CITY OF SUNNYVALE REPORT Planning Commission

August 9, 2004

SUBJECT: **2004-0576** – Fourth Quarter Properties (Partnership Common Names: Forum Development Group, Lehman Brothers and Standard Pacific Homes [Applicant] Target Corporation, WL Partnership, Sun Town Center Properties Corp. (Macy's), Sunnyvale LLC (Mall), and Sunnyvale Redevelopment Agency [Property Owners] application for the redevelopment of 2502 Town Center Lane (Town Center Mall) with a new open-air mixed use shopping district. APN: 209-34-009, 209-34-010, 209-34-016, 209-34-017, 209-34-018, 209-35-001, 209-35-005, 209-35-010, 209-35-011, 209-35-012 and 209-35-007.

Motion: **2004-0576-** Special Development Permit for site plan, design and use approvals to allow the construction of up to 1,000,000 square feet of commercial space, 275,000 square feet of Office space, and 292 housing units.

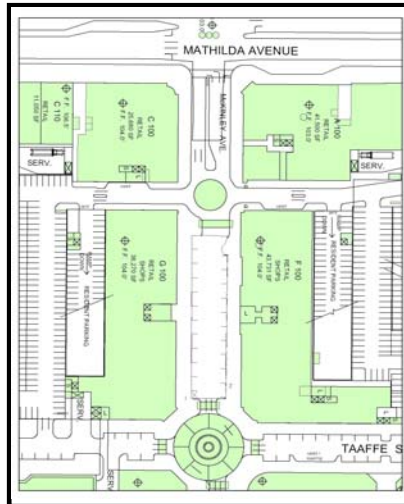
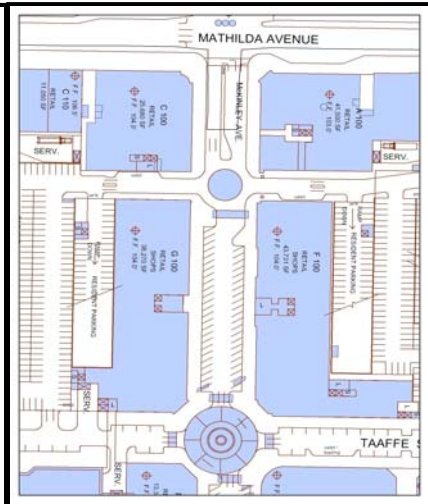
The applicant has provided two schematics to the City on the angled parking layout for the street. The original had a 60-foot curb-to-curb section for parking on both sides and travel lanes, allowing for a typical 20-foot sidewalk. The current proposal of 70-foot curb to curb was submitted in response to maneuvering concerns of the Transportation Division. The current design with parking on both sides has reduced typical sidewalk widths to approximately 15 feet. The applicant would prefer approval of the 60-foot section with wider 20-foot sidewalks based on their experience of design adequacy and preferred pedestrian friendly wider sidewalks.

Contrary to the applicant's proposal for angled parking, the Transportation and Traffic Manager has determined that on-street parking on McKinley Avenue is appropriate as parallel parking. A parallel parking configuration would result in a 50-foot curb-to-curb section and 25-foot sidewalks within the 100-foot distance between buildings. The Transportation and Traffic Division believes that diagonal parking would conflict with the safe and effective functioning of McKinley Avenue as the primary access and central circulatory focus of the proposed development. Although the minimum angled parking dimension of a 70-foot curb-to-curb section, which includes space for bikes, is proposed by the applicant, there remains issues of traffic volume and pedestrian design needs. There is substantial evidence in the traffic engineering literature that diagonal parking increases the collision risk on streets with traffic volumes such as those anticipated for McKinley Avenue. Diagonal parking is operationally inefficient from the standpoint of traffic flow, and traffic flow is essential to this primary circulation corridor.

Furthermore, principles of pedestrian and bicycle friendly design encourage narrower street sections and wider sidewalks; for example the VTA Pedestrian Technical Guidelines call for 10'-11' travel lanes and 16'-18' sidewalks with parallel parking (no bike space) in downtown main street areas. The Transportation and Traffic Manager believes that safe angle parking would necessitate the minimum of 70 feet curb-to-curb, which includes space for bikes. The current plan has provided the 70 feet cur-to-curb with 15-foot sidewalks. Restricted sight lines for drivers also make diagonal parking dangerous for passing bicyclists. Staff believes that diagonal parking with the expanded curb-to-curb width and moderately wide sidewalks will create an automobile-dominated environment, contrary to the goals of the Downtown Specific Plan. Staff is concerned that the amount of pavement, the barrier of

banks of diagonally parked cars, and presence of a significant concentration of cars circulating in an unsafe manner in what is effectively the core of the development will discourage the intended comfortable pedestrian activity.
